# SCCP Modifications

HEATH STEWART, GITESH BHAGWAT, ANDY GARDNER  
SANTA BARBARA DESIGN CENTER

## Modify VOLT\_POWER\_INFO Register to 16 Bits

► Page 109, Line 11:

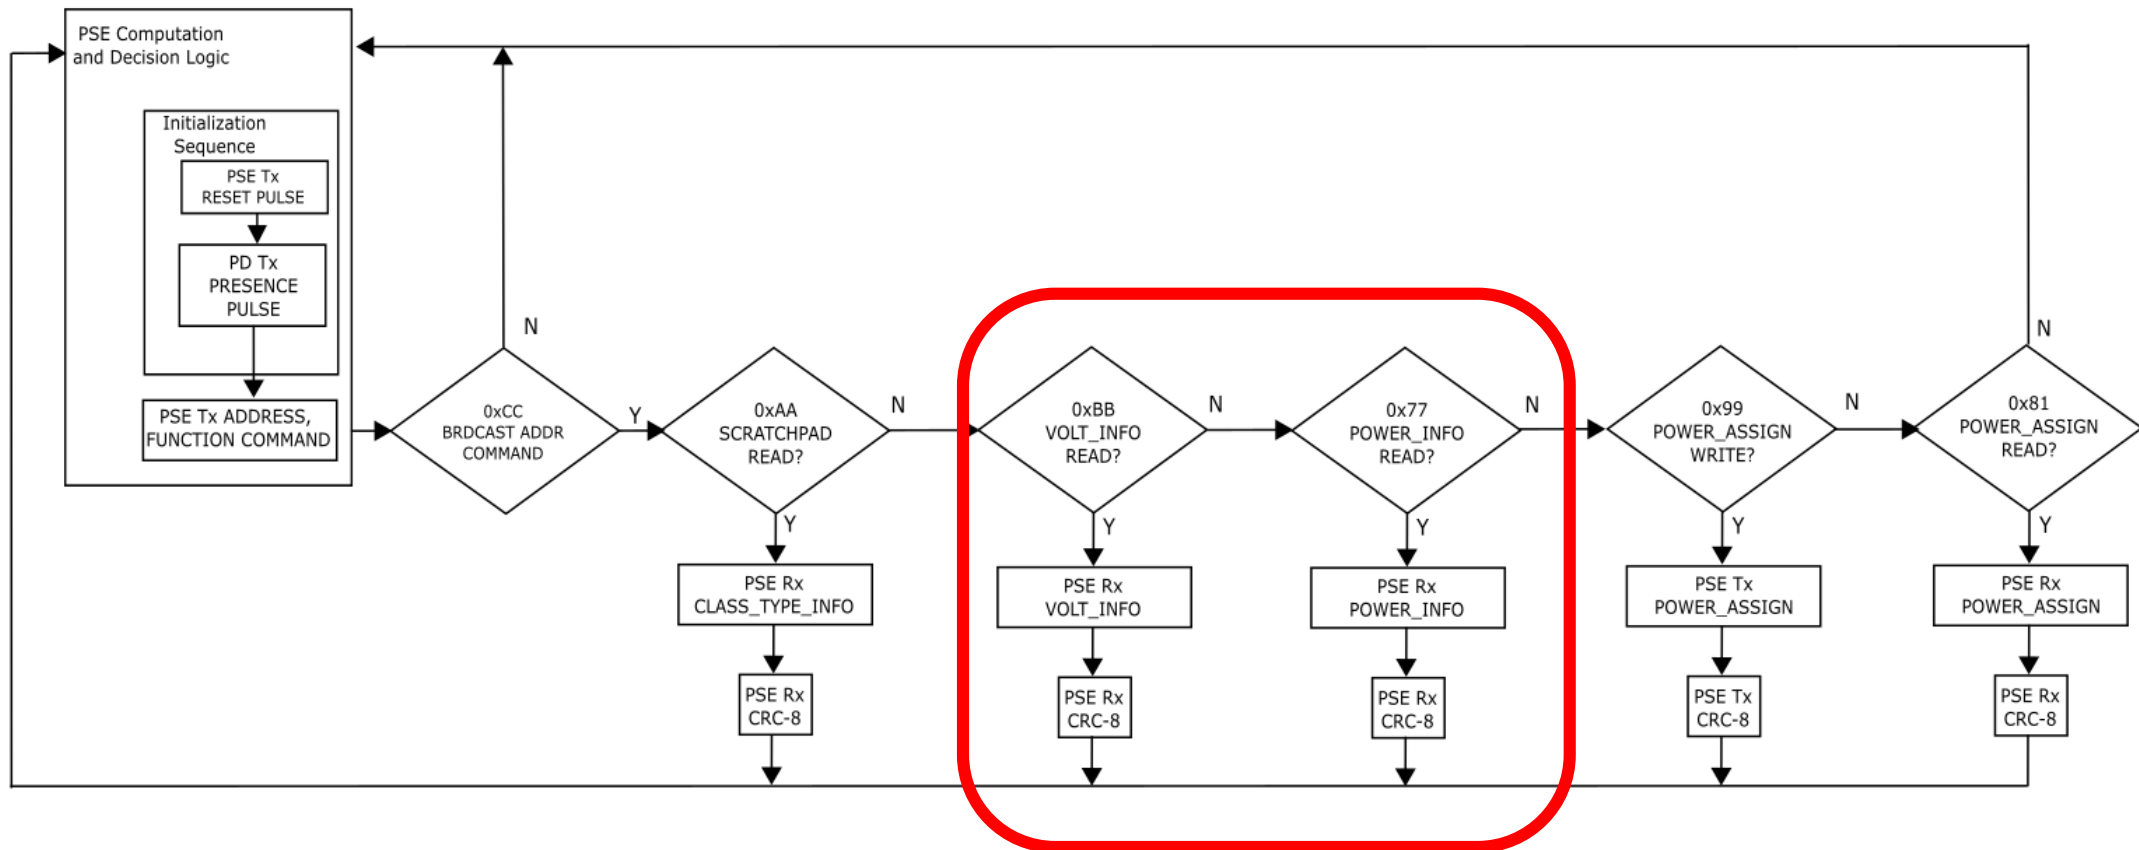
- Modify Figure 104-13 to rename the VOLT\_POWER\_INFO [0xBB] read command and to add the POWER\_INFO [0x77] read command:
